**PARK CITY BOARD OF ADJUSTMENT MEETING
SUMMIT COUNTY, UTAH
May 17, 2022**

- 5.A **741 Rossie Hill -- Appeal of Historic District Design Review Approval --** The Board of Adjustment Will Review the Appeal of the Historic District Design Review Approval for an Addition to the Landmark Historic Structure. PL-22-05235
(A) Public Hearing; (B) Action
[Staff Report](#)
[Exhibit A: Draft Final Action Letter](#)
[Exhibit B: March 10, 2022 Staff Report](#)
[Exhibit C: March 10, 2022 Administrative Public Hearing Minutes](#)
[Exhibit D: Appellant's March 3, 2022 Input](#)
[Exhibit E: Applicant's March 4, 2022 Input](#)
[Exhibit F: Historic District Design Review Final Action Letter and Plans](#)
[Exhibit G: Appellant's Appeal](#)
[Exhibit H: Lilac Hill East Subdivision](#)
[Exhibit I: 741 Rossie Hill Historic Site Form \(formerly 660 Rossie Hill\)](#)
[Exhibit J: Applicant's Letter Objecting to the Appeal](#)

Subject: 741 Rossie Hill Drive
Application: PL-22-05148
Author: Rebecca Ward
Date: March 10, 2022
Type of Item: Modification to a Historic District Design Review

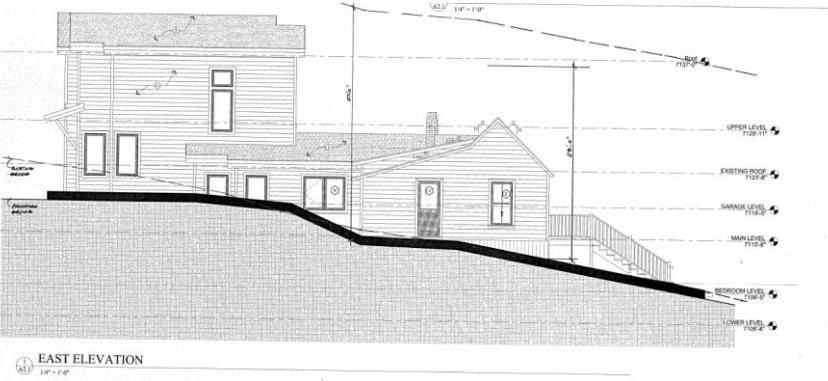
Requirement	Analysis of Proposal
No Structure shall be constructed to a height greater than 27 feet from Existing Grade⁴	Complies The proposed building height does not exceed 27 feet from existing grade.  The drawings show two elevations of a building. The North Elevation (top) shows a two-story structure with a gabled roof. Height markers on the right indicate: UPPER LEVEL 7105'-10", EXISTING ROOF 7102'-0", and LOWER LEVEL 7102'-0". The East Elevation (bottom) shows a side view of the building with a lower section. Height markers on the right indicate: UPPER LEVEL 7105'-10", EXISTING ROOF 7102'-0", GARAGE LEVEL 7102'-0", MAIN LEVEL 7102'-0", BEDROOM LEVEL 7102'-0", and LOWER LEVEL 7102'-0". The building is shown on a sloping site with a dashed line representing the existing ground level.
A Structure shall have a maximum height of 35 feet measured from the lowest floor plane to the point of the highest wall top plate that supports the ceiling joists or roof rafters⁵	Complies The lower level (7105') to the upper-level highest wall top plate that supports the ceiling joists (7137') is 32 feet.

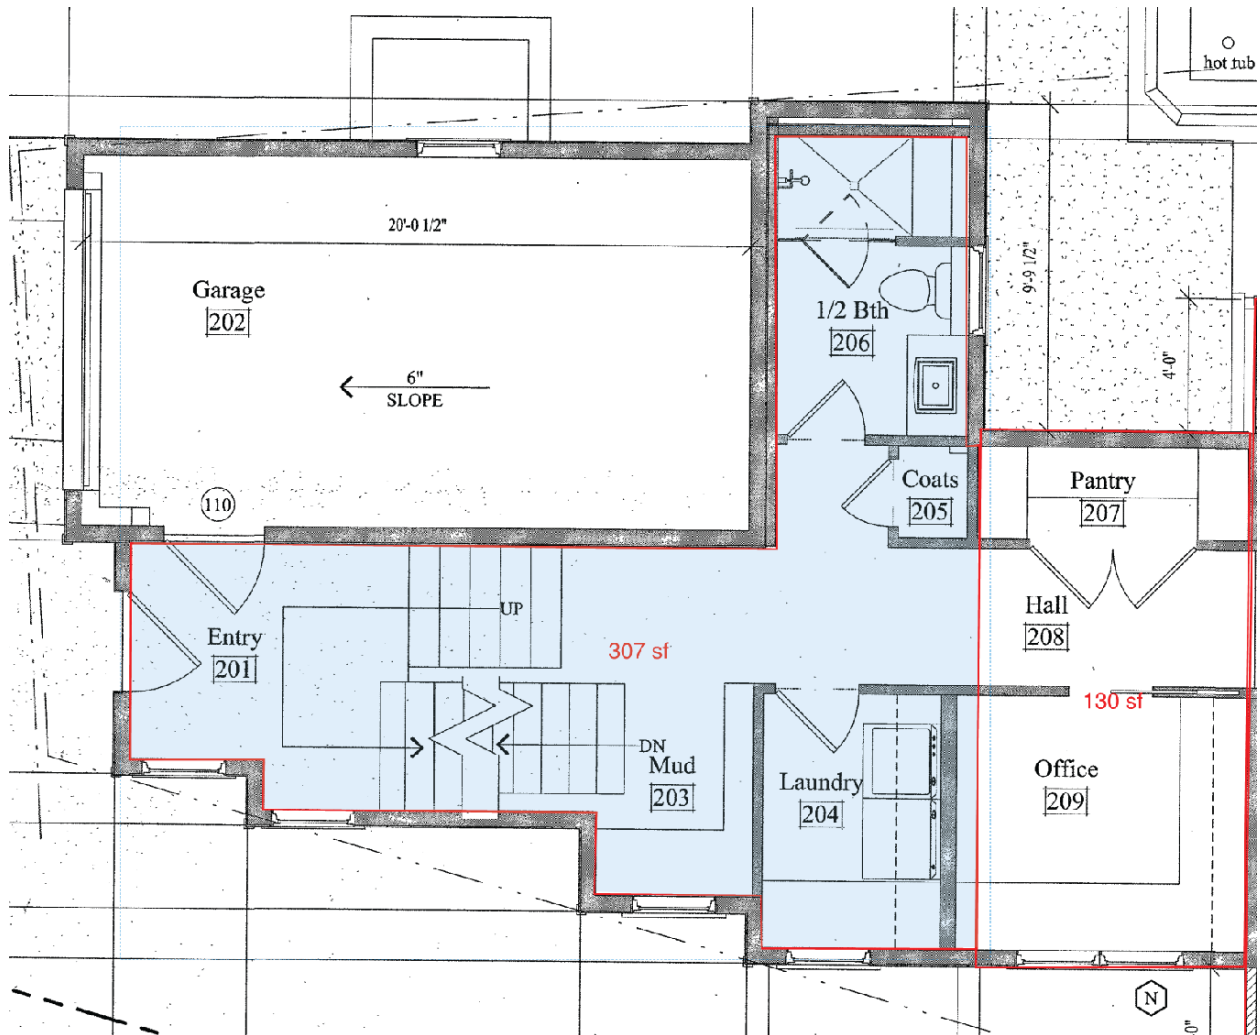
LMC [§ 15-15-1](#) defines Gross Residential Floor Area as “[t]he Area of a Building, including all enclosed Areas, consisting of the Area of all floors located under a ceiling that is above Final Grade, measured in square feet. Unenclosed porches, Balconies, patios and decks, vent shafts and courts are not calculated in Gross Residential Floor Area. Garages up to a maximum Area of [400 square feet in Historic Districts], are not considered Floor Area. Basement and Crawl Space Areas below Final Grade are not considered Floor Area. Floor Area is measured from the finished surface of the interior of the exterior boundary walls.”

The Gross Residential Floor Area of the upper level is approximately 461 square feet, shown in blue below:

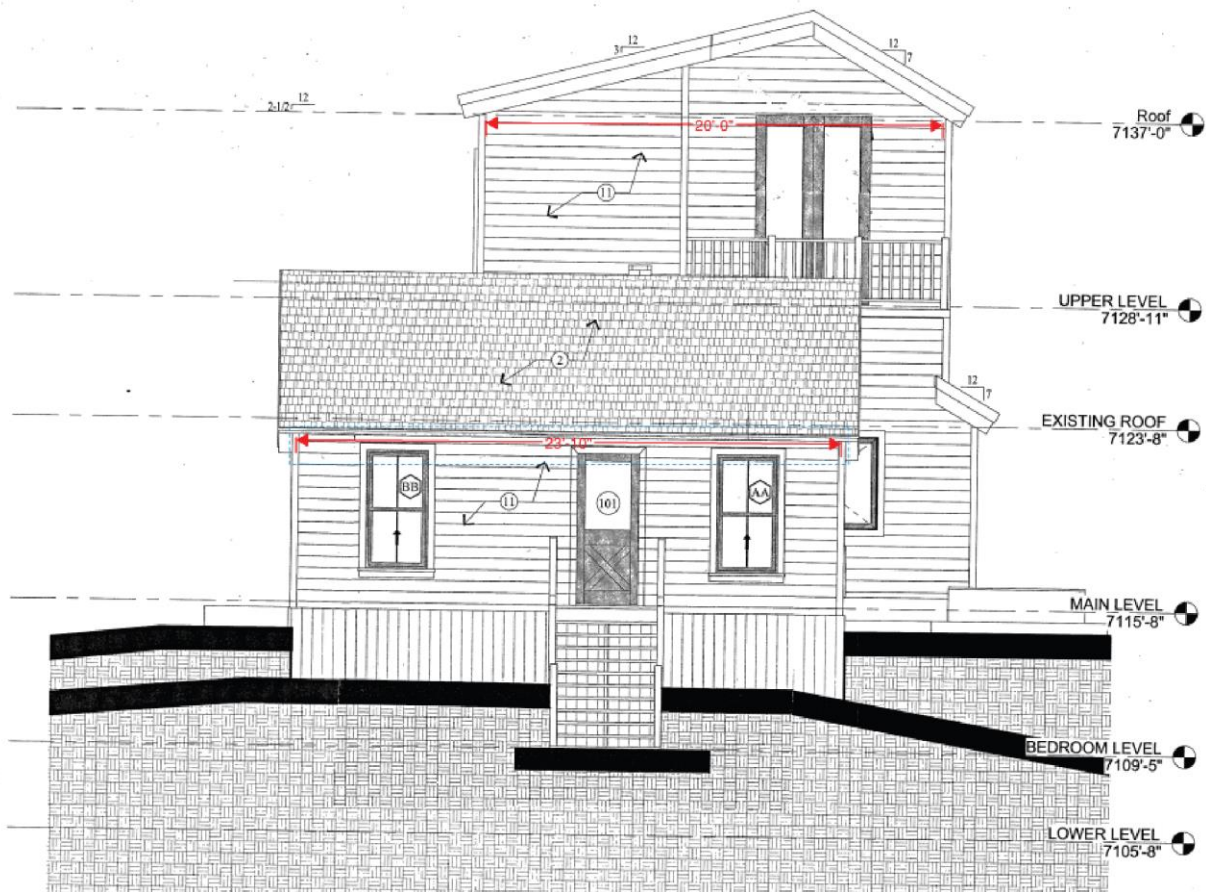
The Gross Residential Floor Area of the proposed addition is approximately 768 square feet.
